ADDENDUM NO. 1

Date: **February 27, 2023**
Issued by: **Sacramento City Unified School District**
Project: **Project #0363-409 Theodore Judah ES Paving Repairs**

KEY PLAN	
➔	
SHEET TITLE: DEMOLITION PLAN	
JOB NUMBER:	SHEET NUMBER:
DATE: NOV 8, 2022	ADD1 C1.1
REVISION:

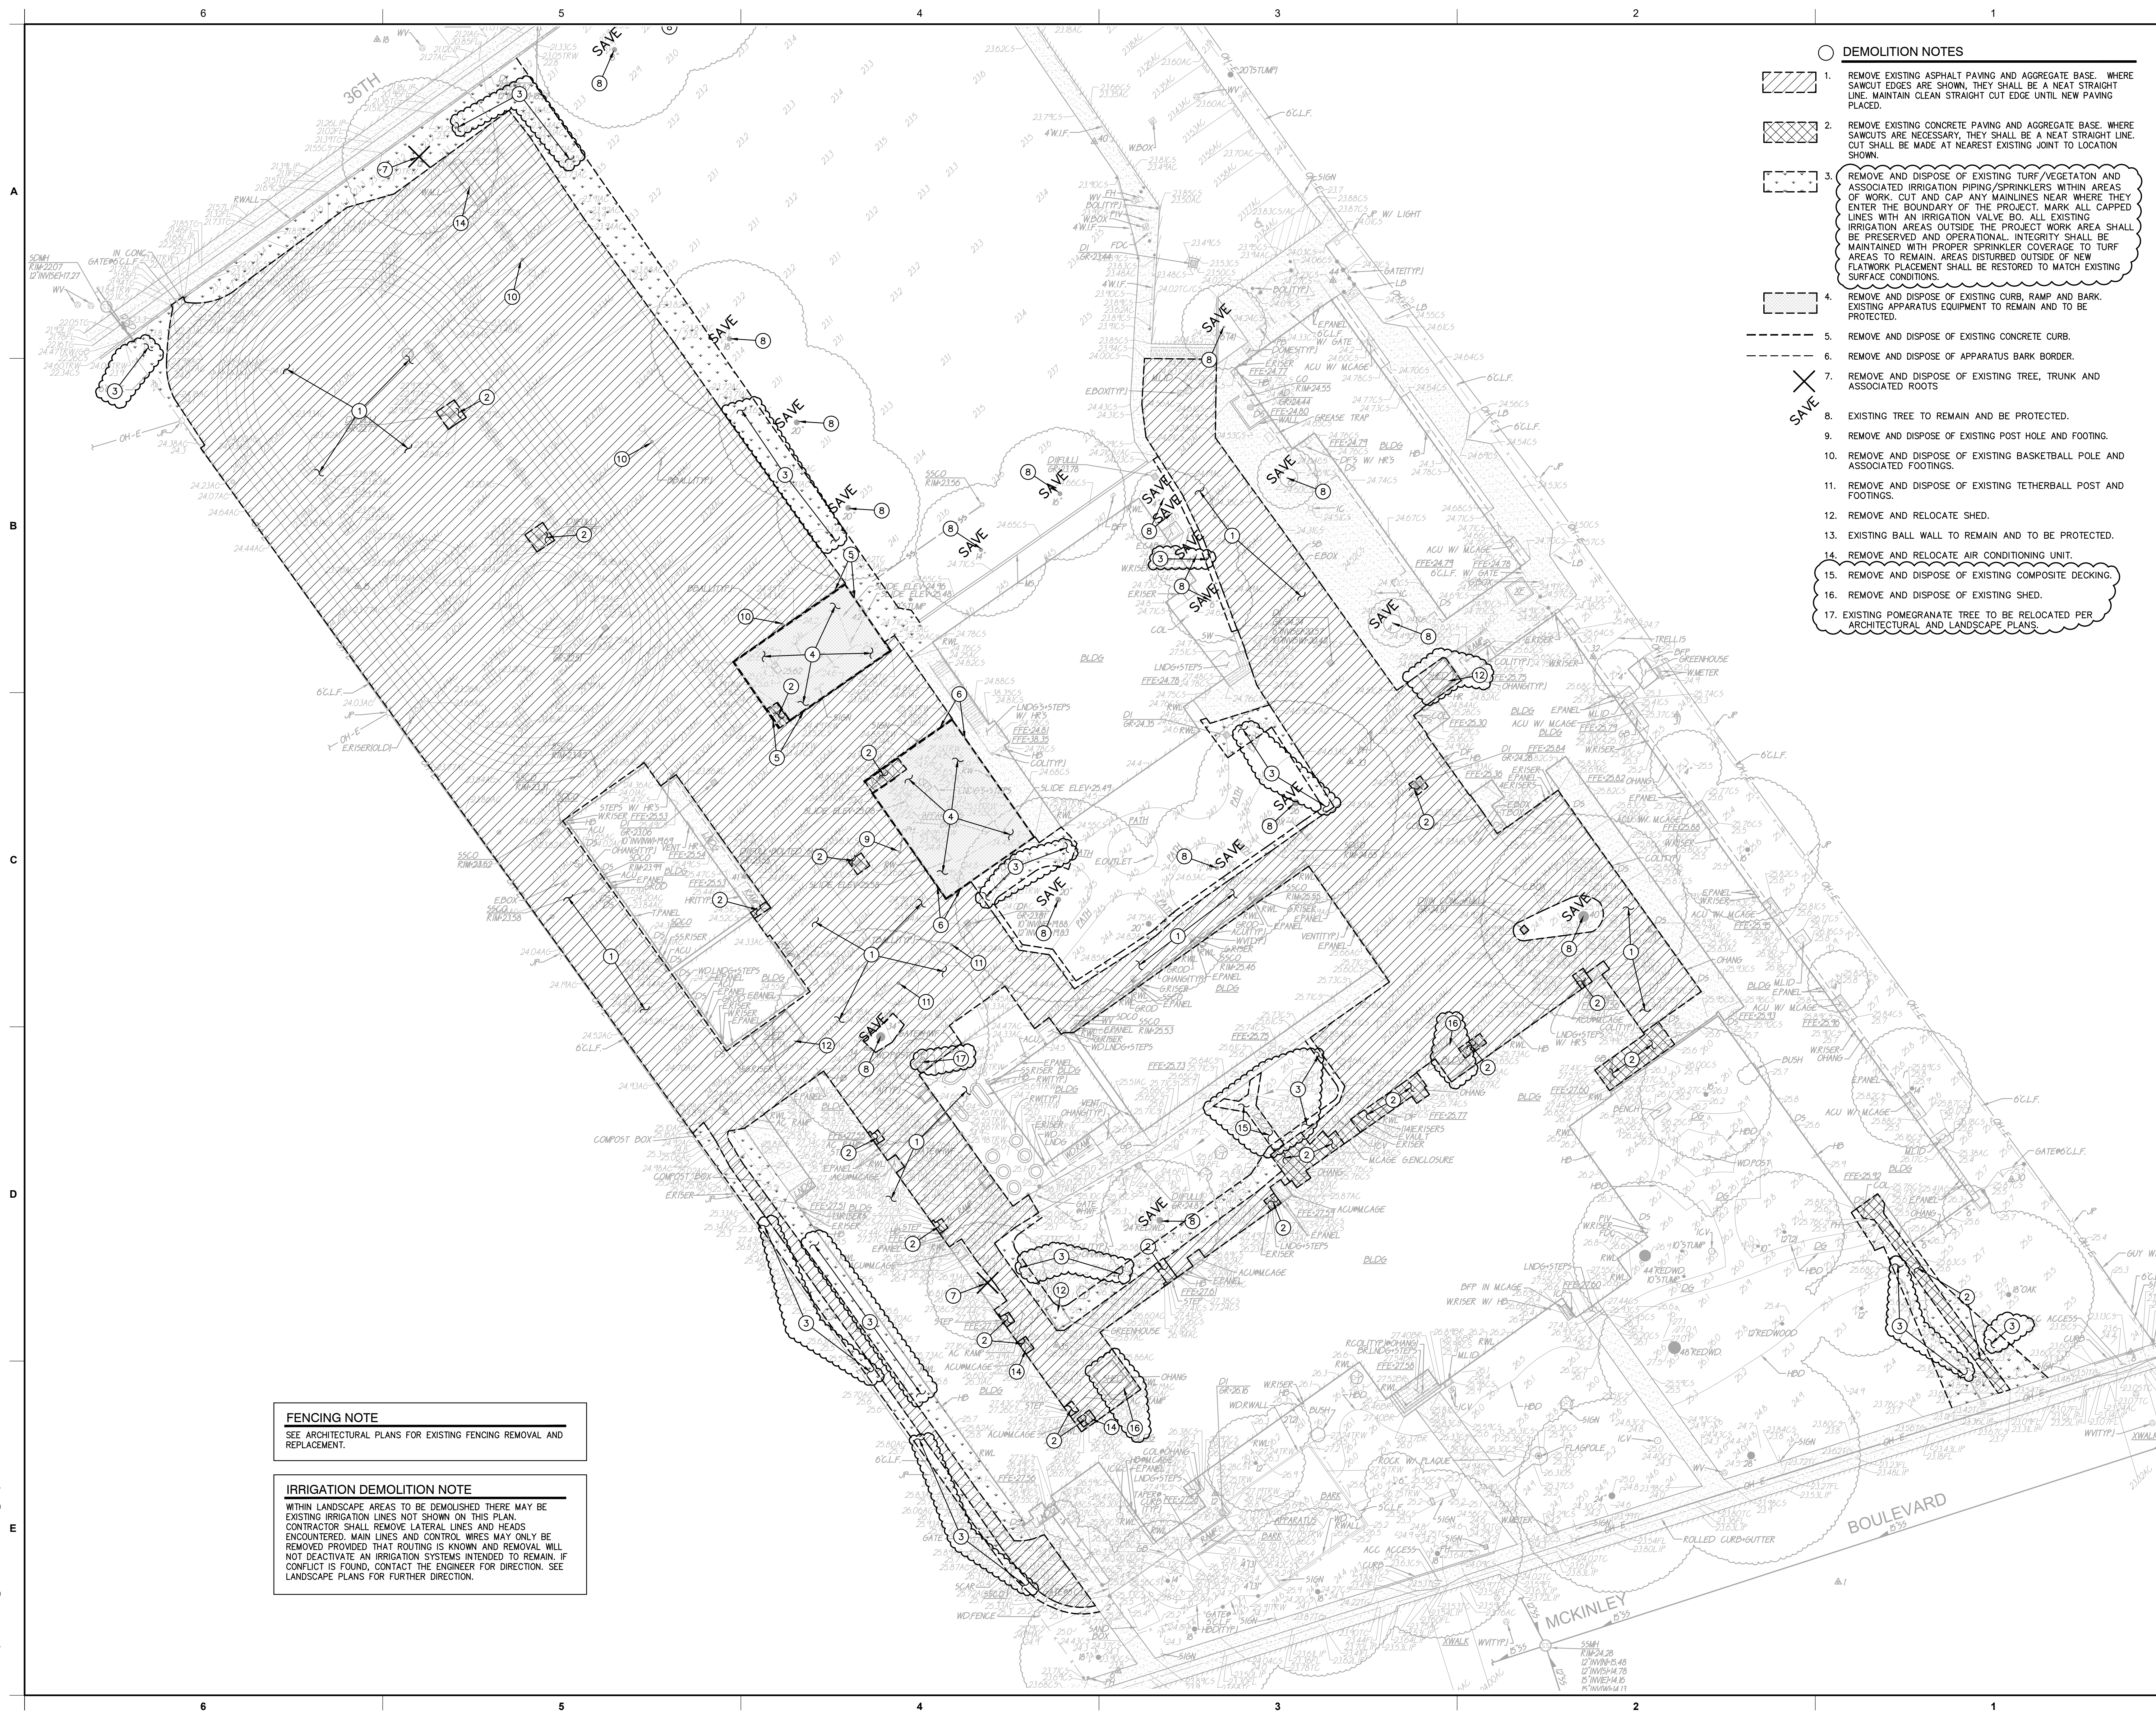
- AD01.07 Sheet C1.1 – Demolition Plan: **Replace with the attached ADD1 C1.1.** Added composite decking to be removed and disposed of, relabeled two shed to remove and dispose of, added one shed to remove and relocate. Added turf and vegetation removal areas within limits of work.

KEY PLAN	
➔	
SHEET TITLE: UTILITY DEMOLITION PLAN	
JOB NUMBER:	SHEET NUMBER:
DATE: NOV 8, 2022	ADD1 C1.2
REVISION:

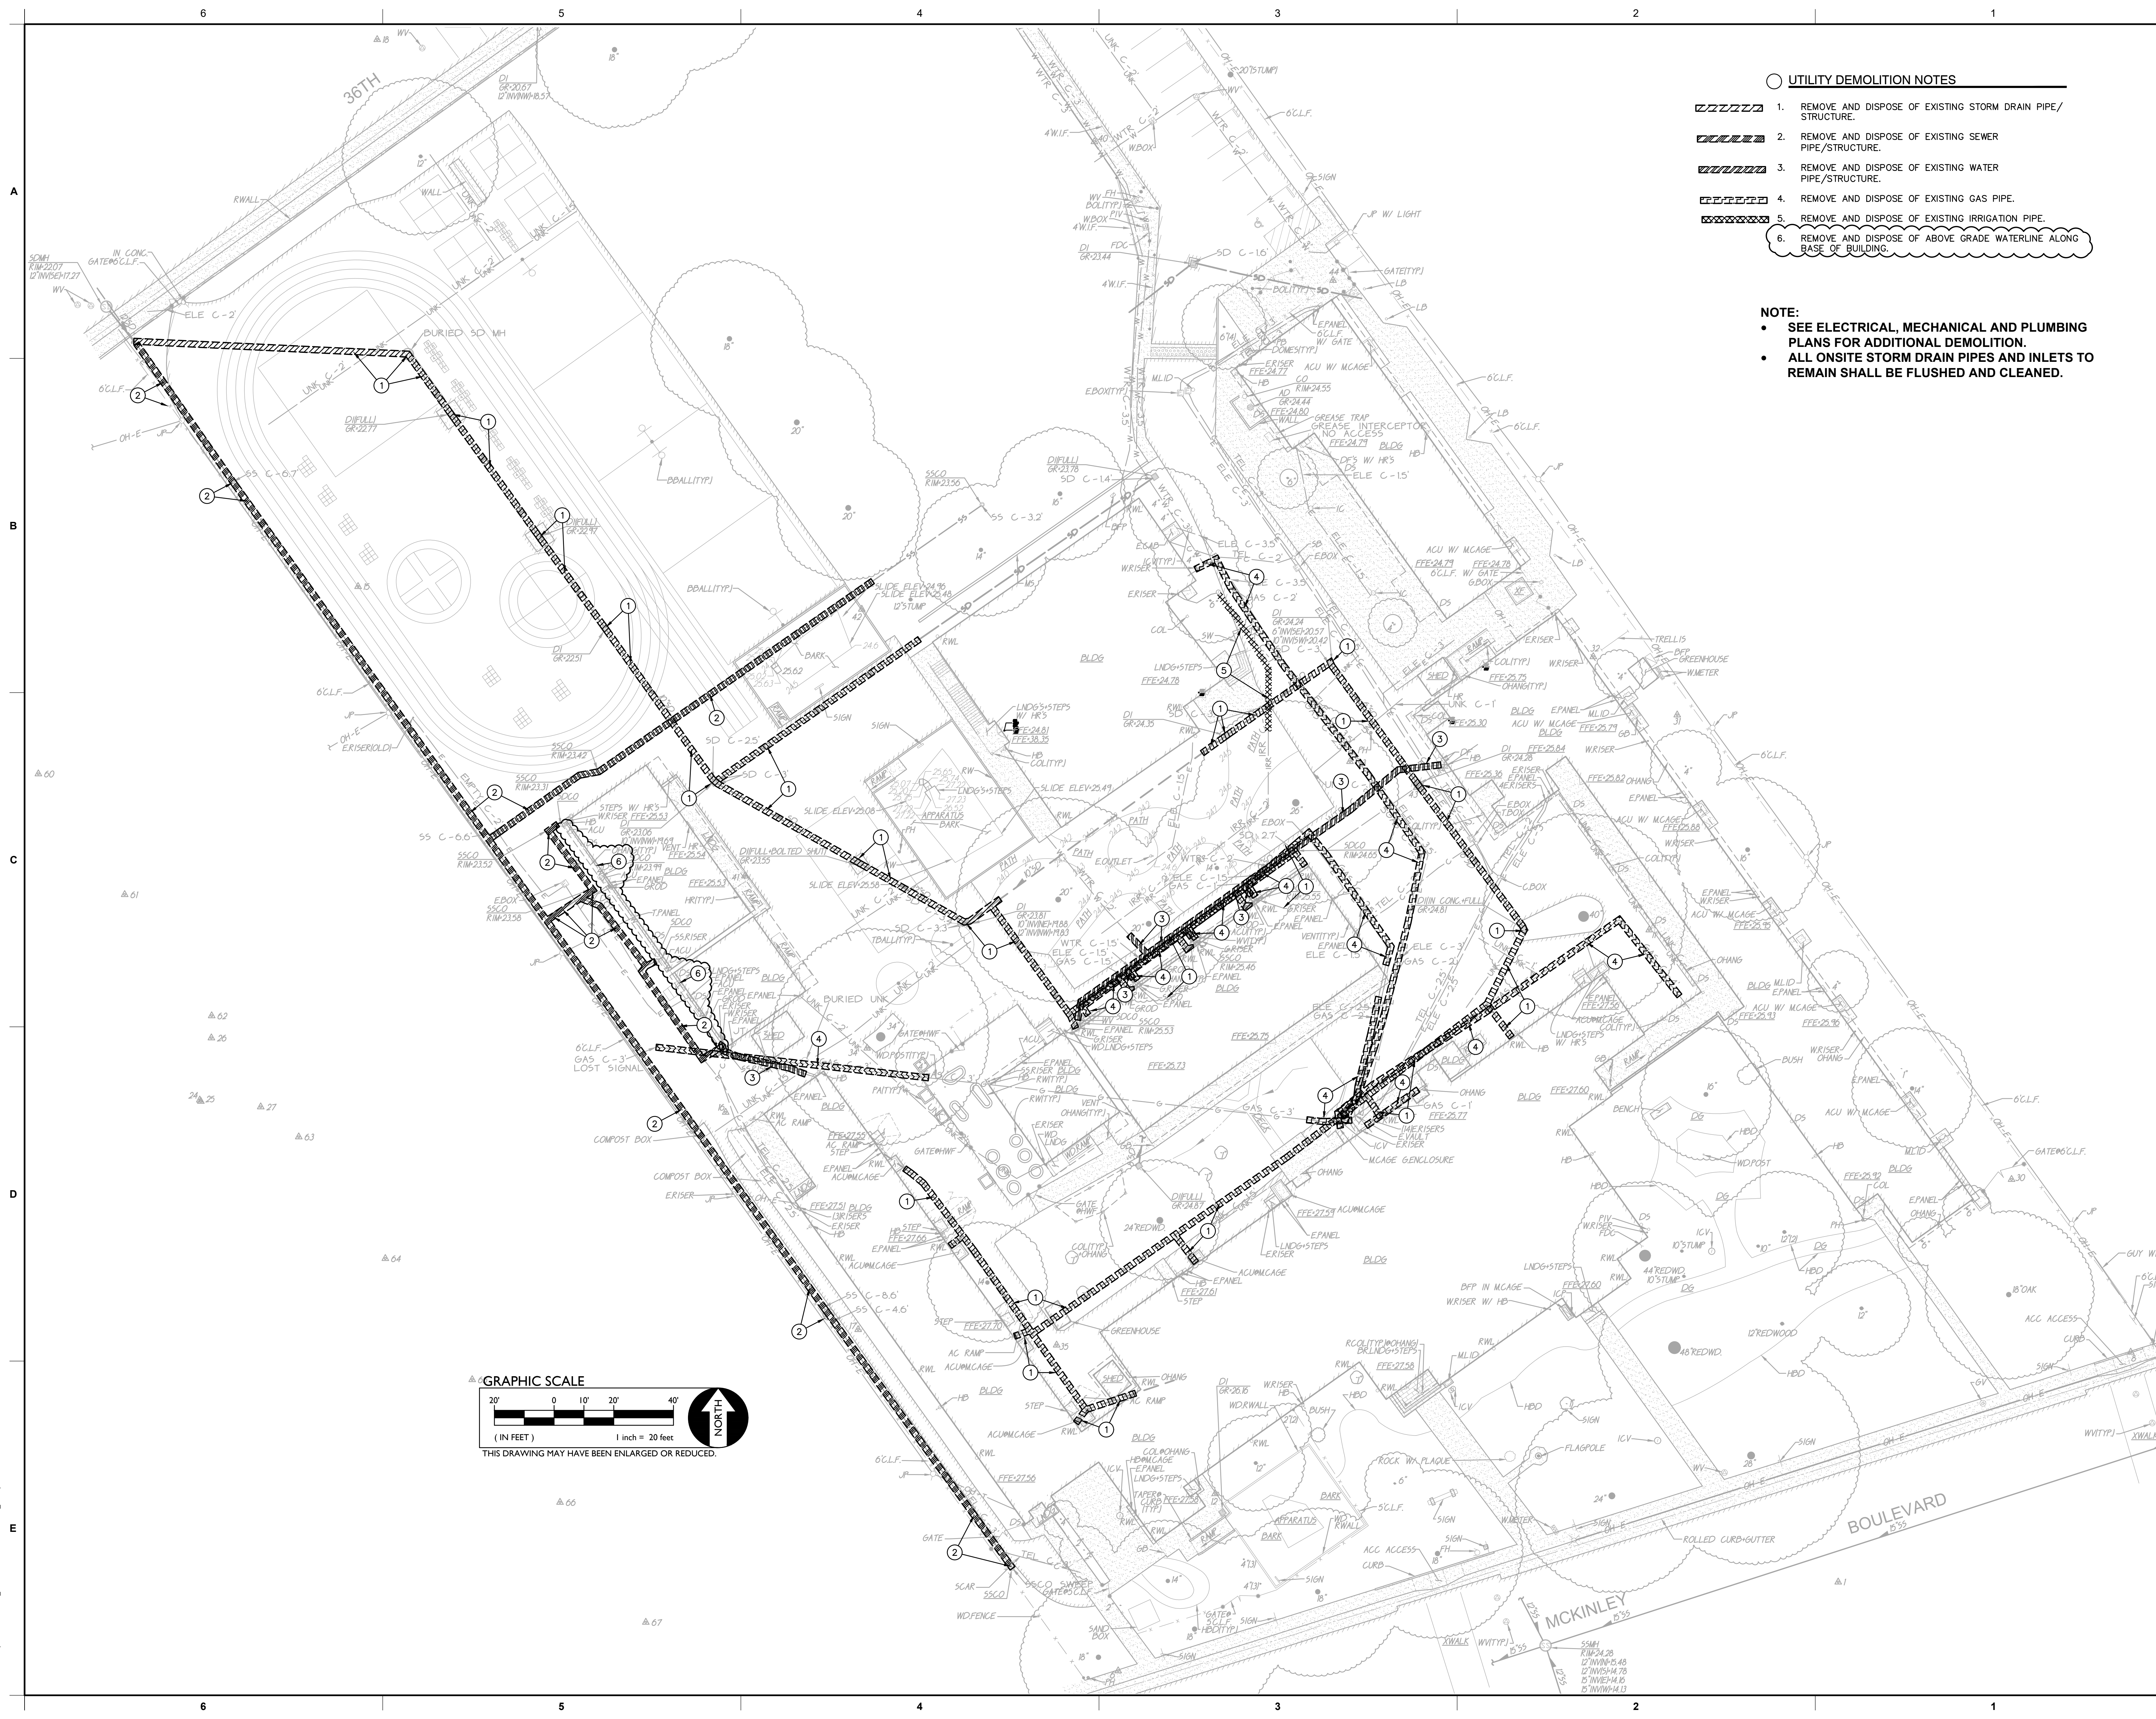
- AD01.08 Sheet C1.2 – Utility Demolition Plan: **Replace with the attached ADD1 C1.2.** Added note to remove above grade water line at back of portable buildings.

SHEET TITLE: ENGINEERED FILL PLAN	
JOB NUMBER:	SHEET NUMBER: ADD1 C1.3
DATE: NOV 8, 2022	
REVISION:

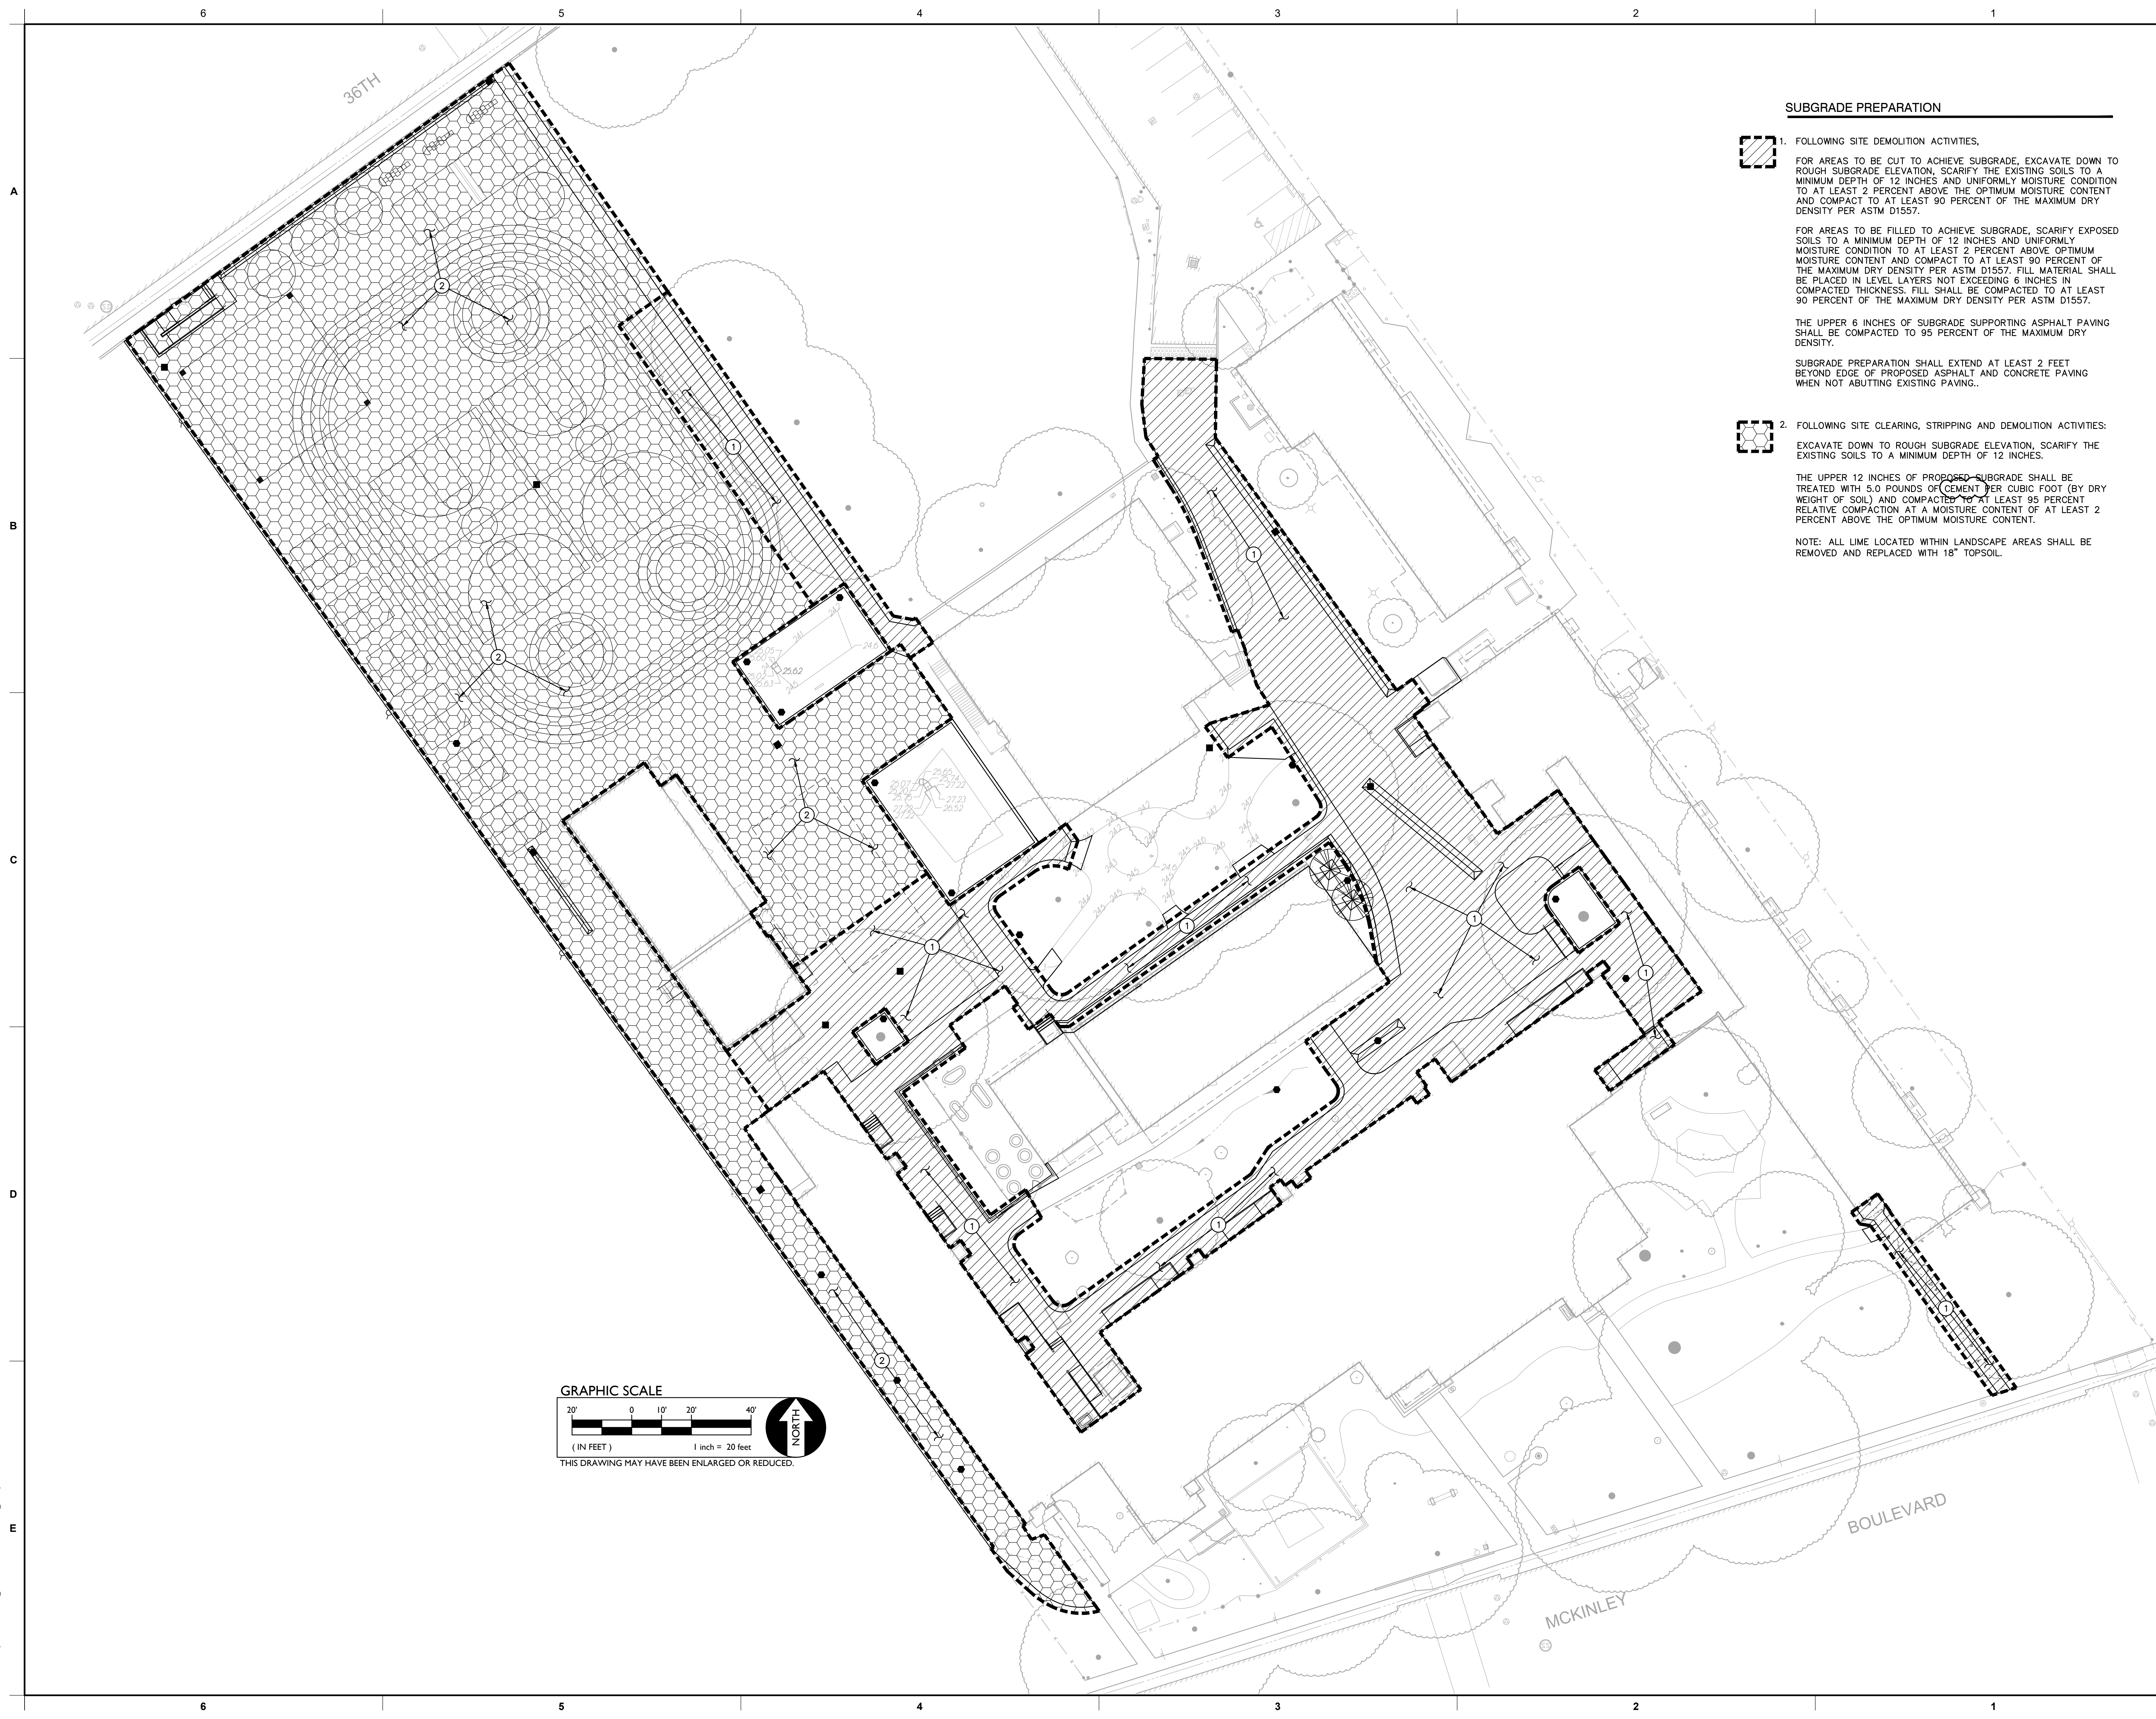
- AD01.09 Sheet C1.3 – Engineered Fill Plan: **Replace with the attached ADD1 C1.3.** Based on the sandy silt soil noted in the Geotechnical Report, lime has been changed to cement. All references to lime treatment throughout the plan set and specifications shall be changed to cement.
